Exhibit A

П	AGT SW JOB NO.	CHECKED: SW DATE:	SKYWAY CORRIDOR PROJECT Town of Paradise	
	PAR006 JULY2012 SHEET REVISIONS: 1 Of 2 SHEETS	Skyway Preferred Alternative Segment A2 -Town Hall to S/O Pearson Road 1 of 2	ľ	
1 -

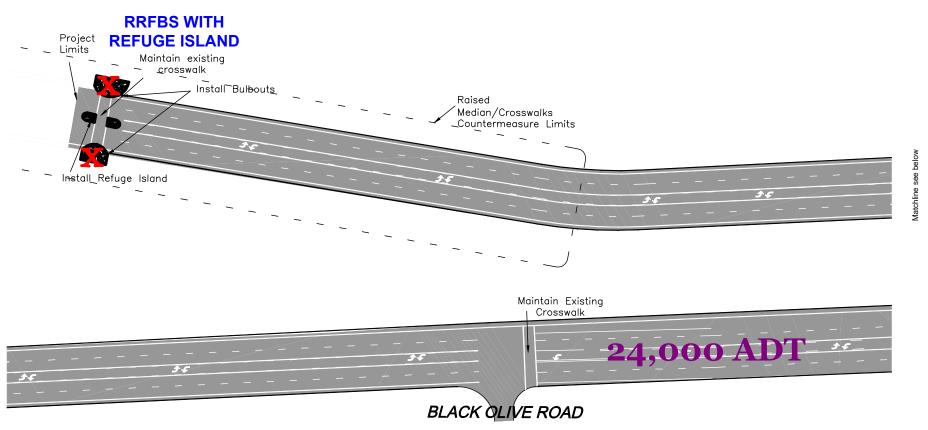
Road Width / ROW does not permit curb extensions here with two lanes in each direction. Ped activated beacons recommended.
